Dolby Laboratories Inc

Field Bulletin 226

No Sound After Reversion from Digital to Analog DA20 with Model SA10 Installed

Issue 1
S99/12648
July 12, 1999

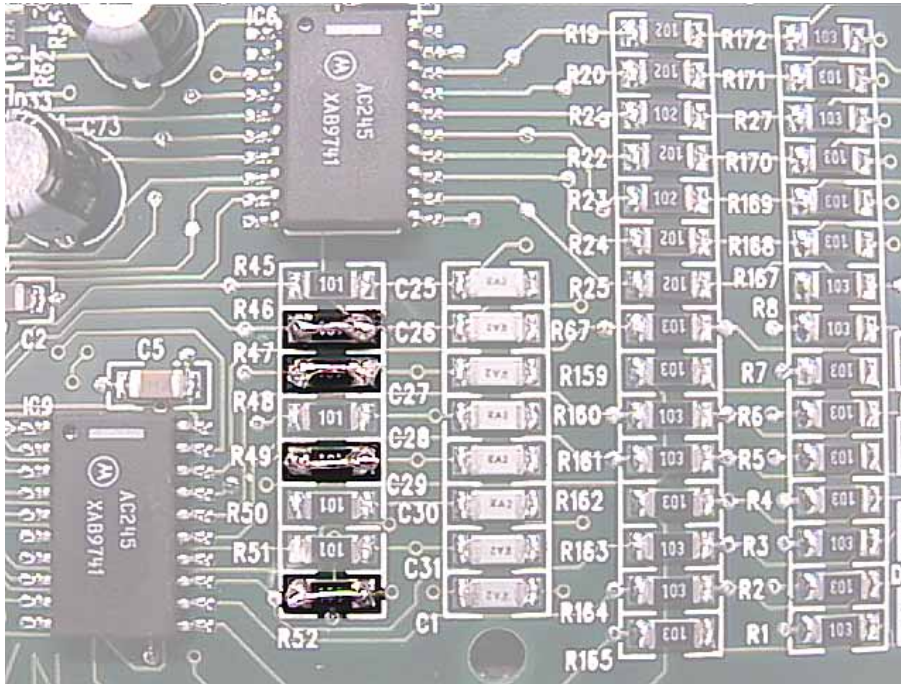
Resistors located on the Cat. No. 611A prevent the reversion command generated by the DA20 from being accepted by the CP65/55. The CP65/55 will not switch to format 05 (SR).

The solution involves shorting four surface-mount resistors on the Cat. No. 611A board.

4. Find the short column of surface-mount resistors located toward the bottom of the card as shown in the photograph.

5. Using a low-wattage soldering iron (35W or less) and a very thin piece of wire, short resistors **R46, R47, R49 and R52**. Link across the body of each resistor. If you use too much heat, the resistor may inadvertently unsolder. If this happens, carefully use the same thin wire to jumper the remaining two solder pads on the board.
